**City of Puyallup**  
Development & Permitting Services  
**ISSUED PERMIT**

**Site Plan**  
A 236-Unit Apartment Project

**Bradley Heights Apartments**  
Puyallup, Wa

A2

**SITE PLAN** 236 UNITS  
1" = 40'

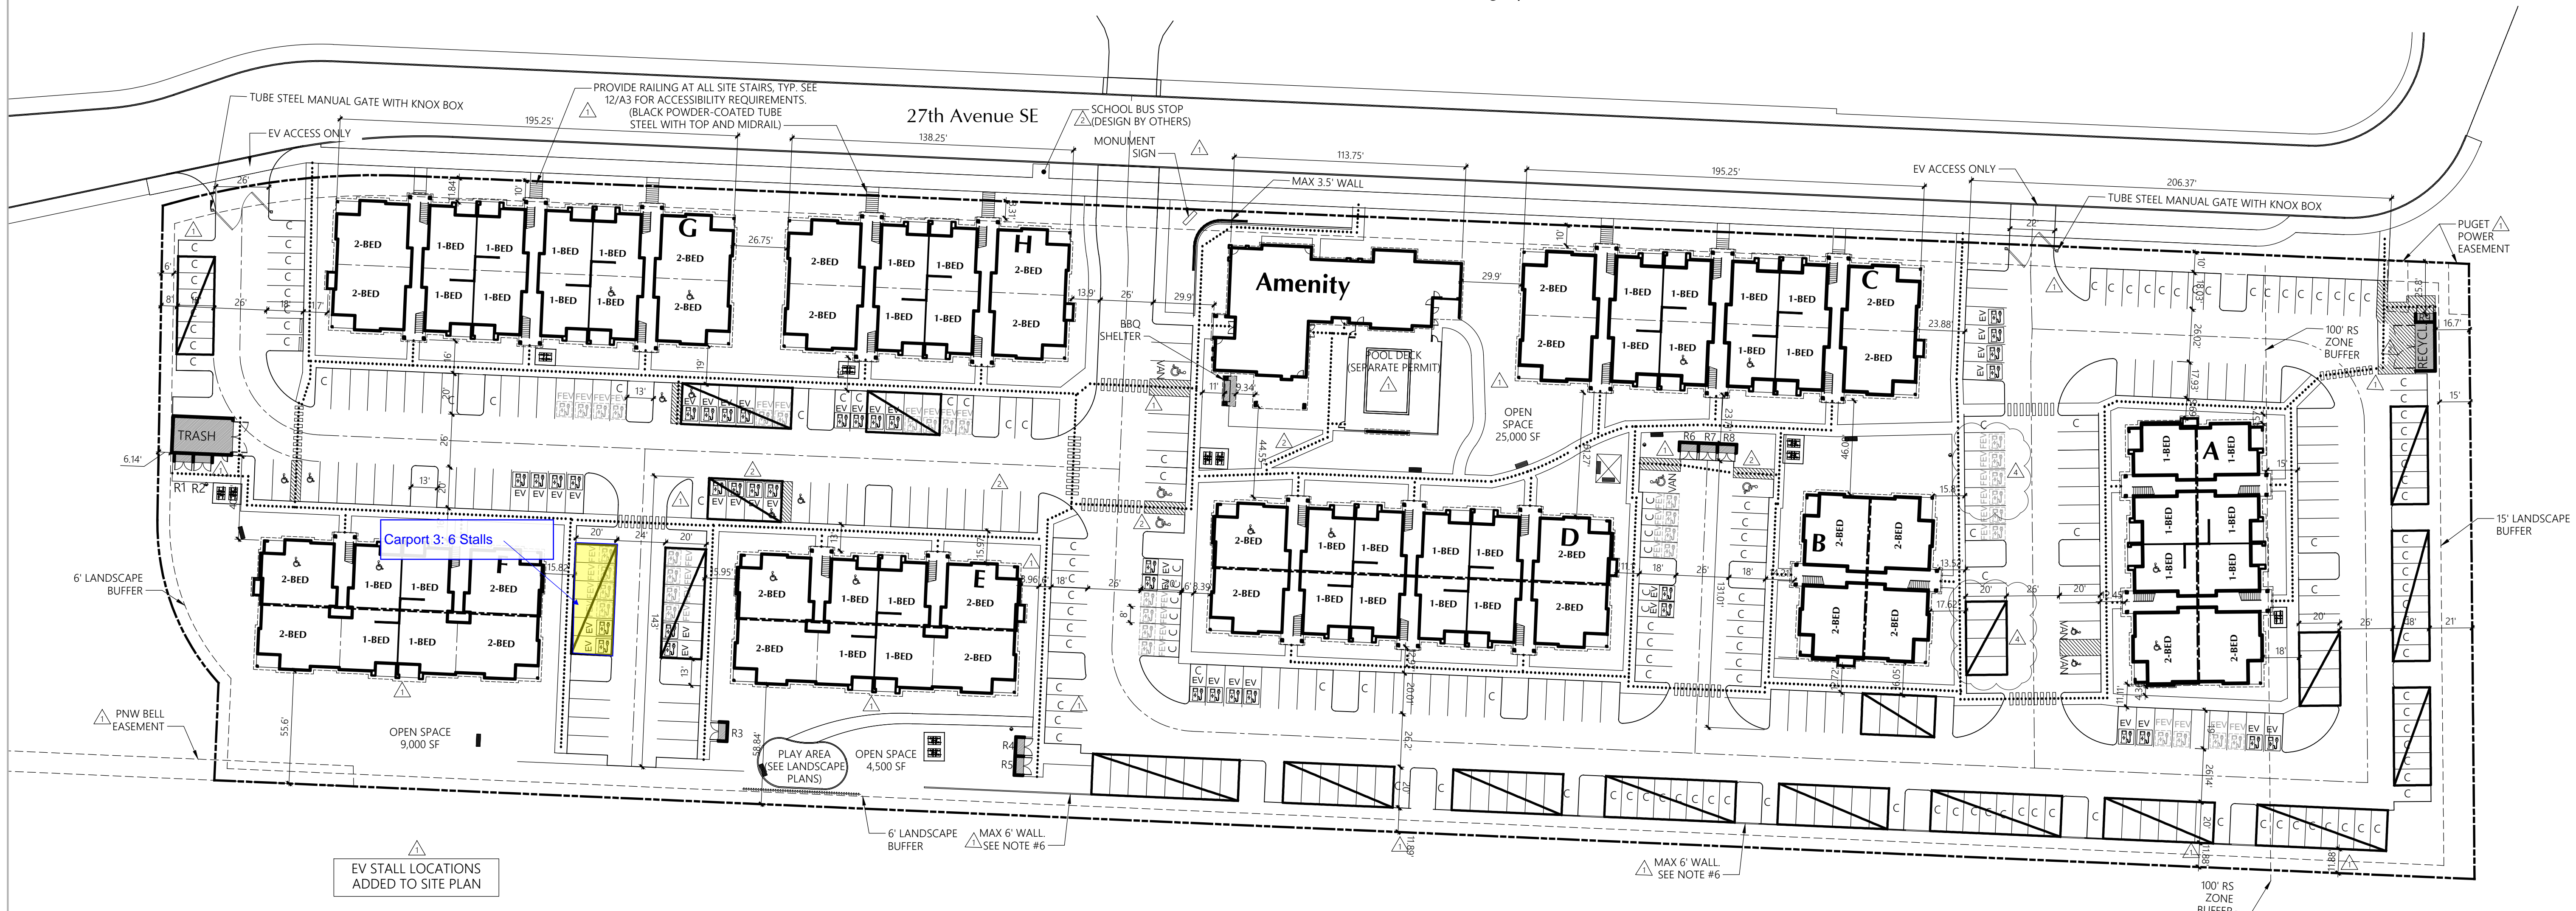
No proposed footings, posts, or supports shall be constructed on or above any existing public utility connections without first relocating the utility services or protecting it in place.

Roof downspout control is required. Steps shall be taken to prevent drainage onto adjacent lots. Refer to City standard details 02.05.01 & 02.05.05 for typical control methods. Stormwater runoff shall not concentrate to neighbors.

EV STALL LOCATIONS ADDED TO SITE PLAN  
EV STALL LOCATIONS UPDATED

PARKING COUNTS CORRECTED
